# SLOVENSKI STANDARD SIST EN 1949:2011/kFprA1:2012

# Specifikacija za vgradnjo sistemov na utekočinjeni naftni plin (UNP) v bivalna vozila za prosti čas in druga vozila - Dopolnilo A1

**SIST EN 1949:2011/kFprA1:2012**

## FprA1

Figure 11 — possible LPG Tank and cylinder installation"

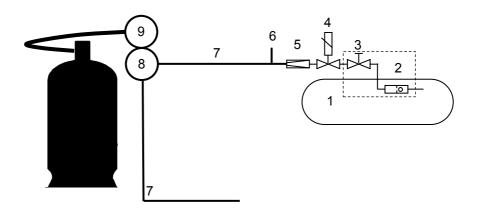
Replace the Figure 11 and the key by the following:

- 1 LPG tank
- 2 excess flow valve
- 3 service valve
- 4 remote shut-off valve (alternative)
- 5 regulator
- 6 test point
- 7 rigid piping
- 8 manual change over device
- 9 regulator (cylinder side)
